November 30, 2021

**RE: Harbor Grove Preliminary Plat Application
9110 53rd Ave W**

Figure 1 – French drain and connection to stormwater collection system

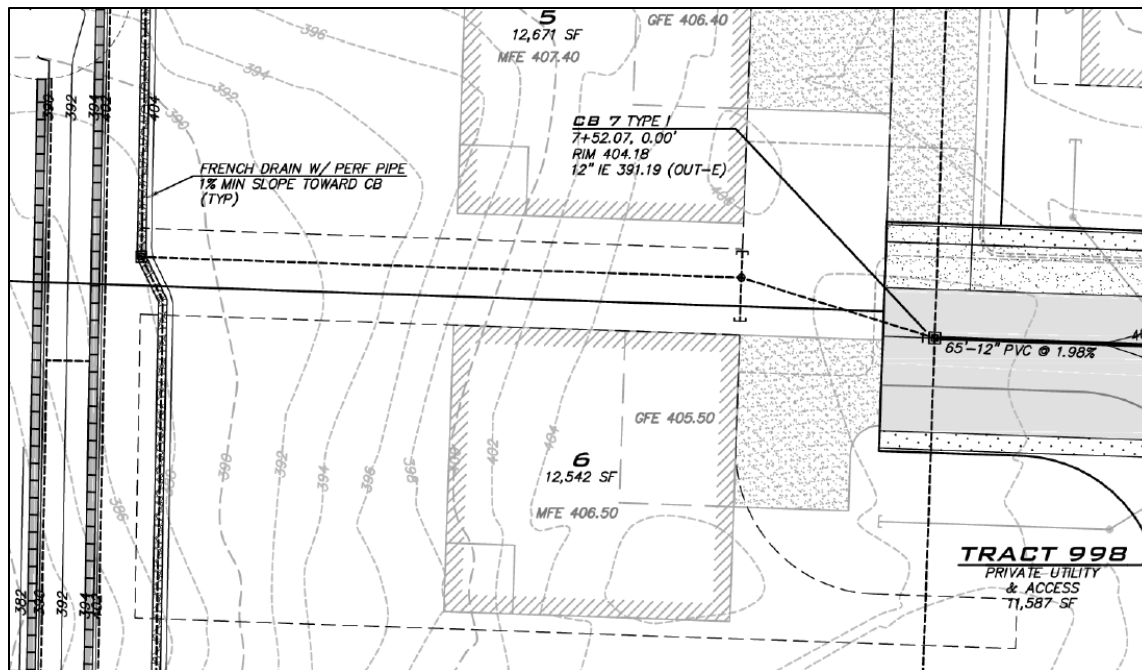
French drain. The proposed french drain to be installed across Lots 4-7 will be buried under approximately 10-12 feet of fill dirt (see Sheet 7 of the preliminary plans and Figure 1 below). How will this drain be maintained? What will happen if it fails? Will it be possible to bring equipment into the back yards of future homeowners and dig a 12 foot deep trench? Future property owners will have no incentive to maintain the drain systems because failure would mostly impact other properties outside of the development. My guess is this drain will never be maintained or repaired, and if it fails, it will cause major drainage issues for my property and my neighbors. Such a failure would be nearly impossible to detect and locate, much less to fix. There is also a possibility that future homeowners will cover the drain area with patios and other hard surfacing, making it less effective.

The french drain will flow back to the east in a pipe connected to the detention system. The slope gradient of this pipe is specified at a minimum of 1%, which is barely enough for the water to flow in its intended direction (see Sheet 7). In order to flow back to the east, this drain will need to be installed at a minimum elevation of 393' because the catch basin elevation will be set at 391' (Sheet 7 and Figure 1, below). The french drain collection pipe will be *above* the existing grade level of approximately 386' to 392'. This is significant because the drain will be at too high of an elevation to capture all of the site's subsurface drainage. It would be located above the layer of glacial till that underlies the site. Because of the site's sloping topography, water is likely pass *under* the pipe, contact the glacial till layer, and migrate to the west. And what would happen if the site were to experience post-development settlement, changing the gradient of the pipe? Could it potentially stop flowing? These are valid questions since the proposal is to place a massive amount of fill material on the site.

The effectiveness of this project's subsurface drainage system will be reduced as a result of the applicant's design objective of sending collected water back to the east. System improvements, including the french drain, would be installed at too high of an elevation. The City should require the applicant to prepare an alternative design that places the subsurface drainage collection system at a lower elevation to more effectively capture subsurface water. The design should be prepared in close coordination with a groundwater study and a revised soils study. Long-term access and maintenance provisions should be included for this or any system.
